**ADMINISTRATIVE INFORMATION****FMI No: 25320****FMI Title: LightSpeed 16 Power Supply Cable Upgrade**

FMI No.: 25320 FMI Title: LightSpeed 16 Power Supply Cable Upgrade

The purpose of this FMI is to replace DAS DC power cabling with current production parts and to install chassis to chassis cable mounting brackets.

Figure 1 - Cable Clamp Brackets

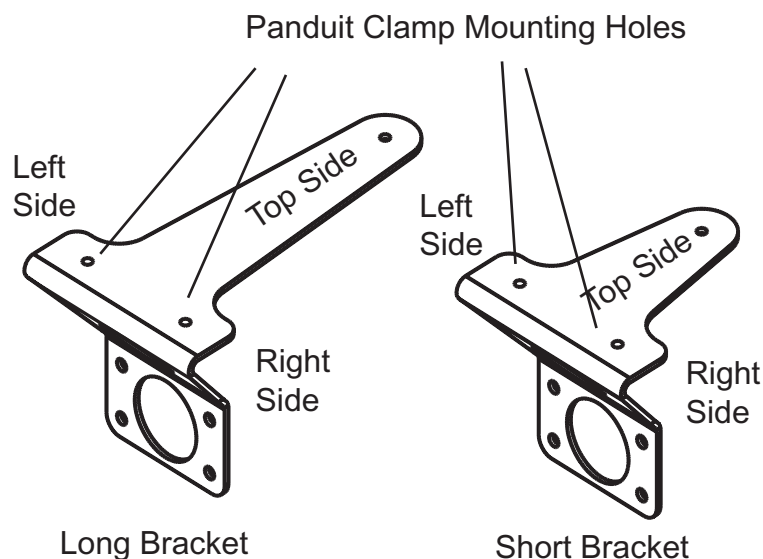
- 1.) Turn off Axial Enable, HVDC and 120 VAC Service switches located on STC backplane.
- 2.) Turn off the DAS power switch located on the DAS Fuse box.
- 3.) Attach one (1) panduit cable clamp to the top side of the four (4) brackets. [See Figure 1.](#)
 - a.) Use Loctite 242 on each screw.
 - b.) Attach one (1) panduit clamp, open or locking end, facing the left side of both the short and long brackets.
 - c.) Attach one (1) panduit clamp, open or locking end, facing the right side of both the short and long brackets.

Figure 2 - Bracket mounting detail

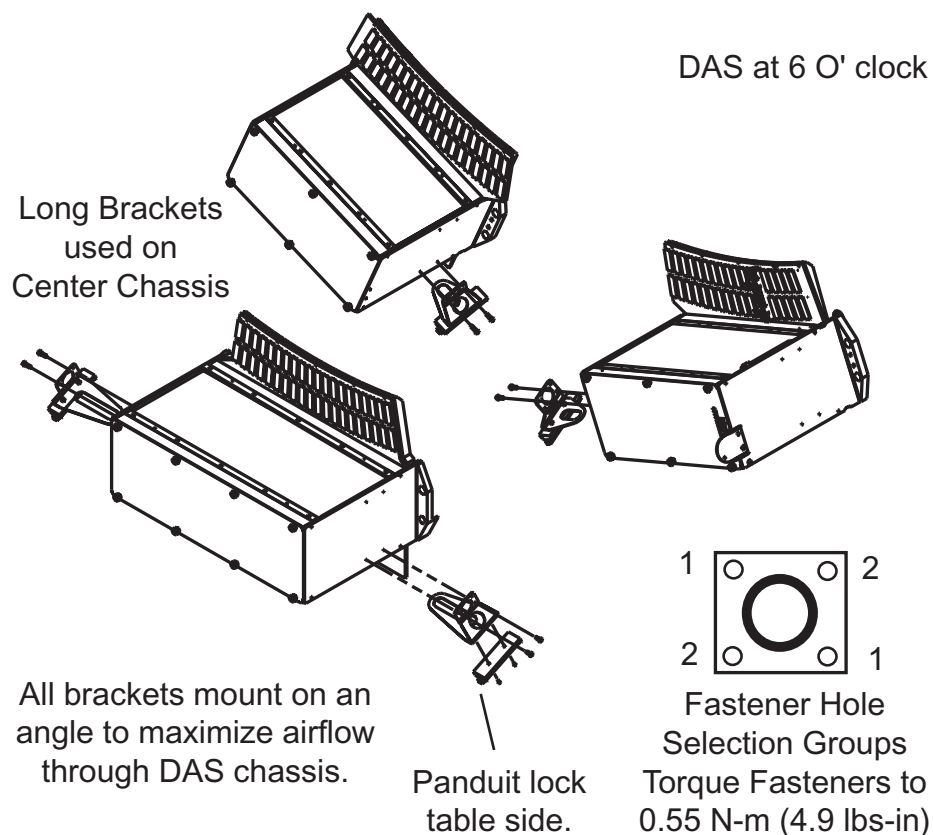
- 4.) Rotate gantry for easy access to DAS chassis.
- 5.) Mount long brackets to DAS center chassis. [See Figure 2.](#)

- a.) Use Loctite 242 on each screw. Torque to 0.55 N-m (4.9 lbs-in)
- b.) Ensure Panduit clamps open or locking end is table side.
- c.) Mount brackets so they extend over the top of the DAS chassis.
- d.) Mount brackets on an angle such that bracket slopes toward the rear of the gantry. This maximizes the space between the bracket and the top of the DAS chassis. Use hole pattern 1 or 2 to achieve correct bracket slope.
